Docket Number:	21-BSTD-01
Project Title:	2022 Energy Code Update Rulemaking
TN #:	238418
Document Title:	Carrier Corporation rev 2 Comments - Title 24 2022 Building Energy Efficiency 45 Day Review
Description:	N/A
Filer:	Chester Hong
Organization:	California Energy Commission
Submitter Role:	Commission Staff
Submission Date:	6/22/2021 10:16:04 AM
Docketed Date:	6/22/2021

Introduction and Background

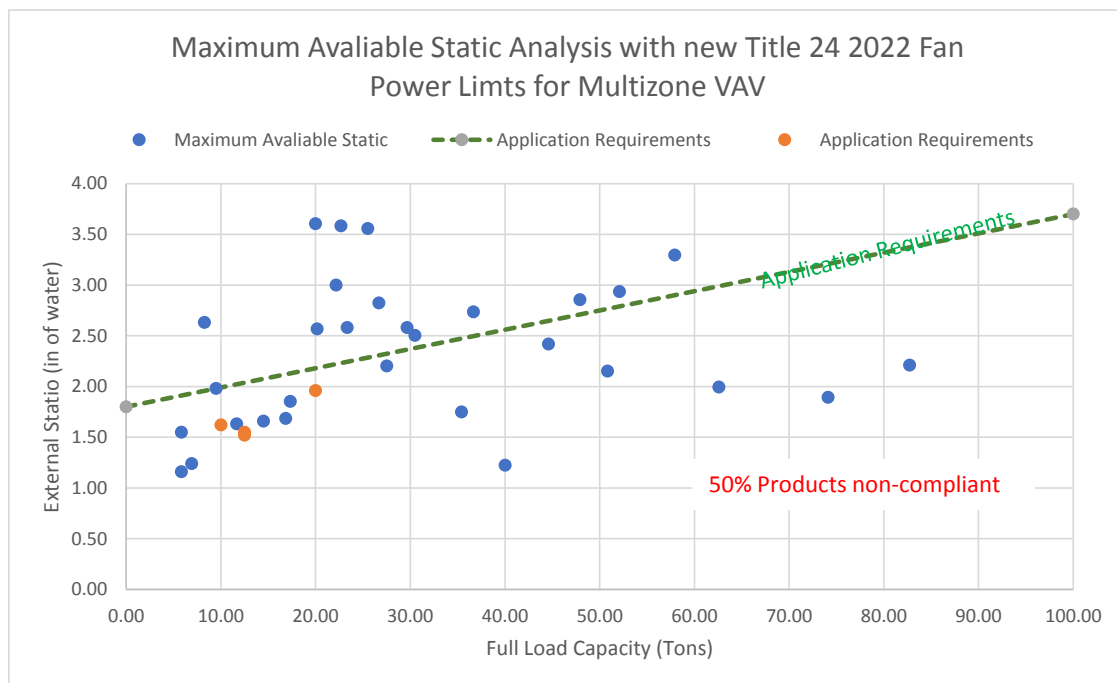
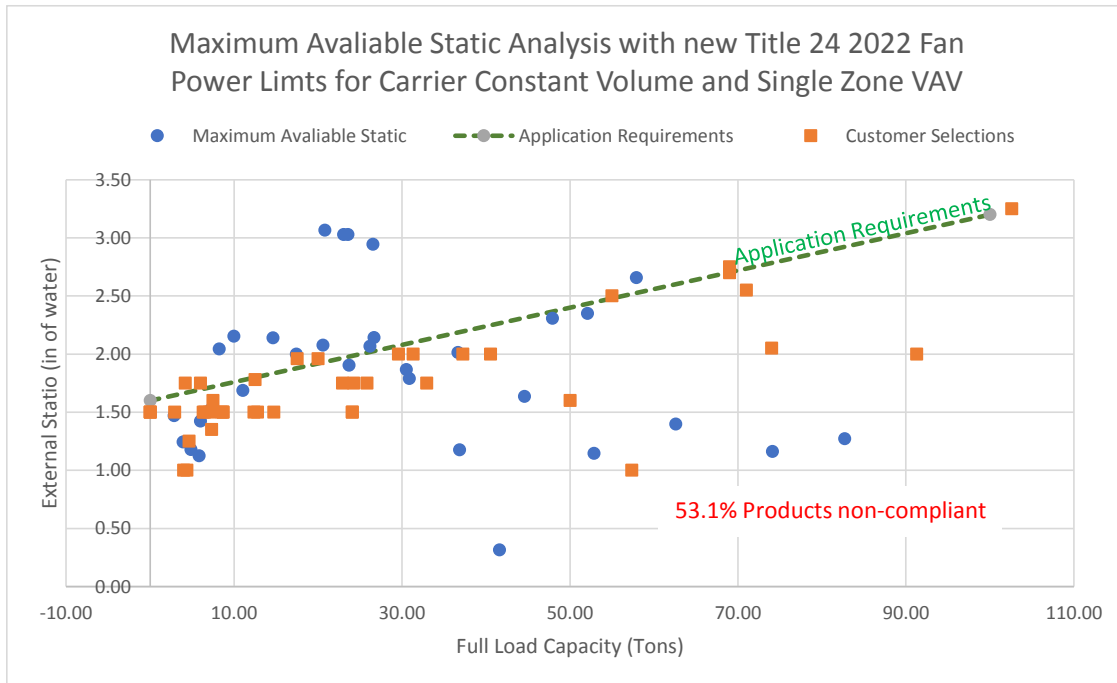
To understand the customer requirements we took all our planned rooftop design for 2023 efficiency requirements and for a basic rooftop with gas heat, economizers and down supply on new construction we determined what external static that could be supplied. We did this for constant volume and variable volume and the results are shown in the following two plots. We also gathered data from customer specifications and developed a curve of what we believe the minimum external static requirement allowance should be as shown by the orange squares

and the green curve fit line. We were able to get significant data for constant volume, but only limited data for VAV. We believe VAV should be slightly higher due to the added pressure losses of terminals.

As you can see 53.1% of the CV units and 50% of the VAV would not even be able to provide the assumed customer requirements specification line.
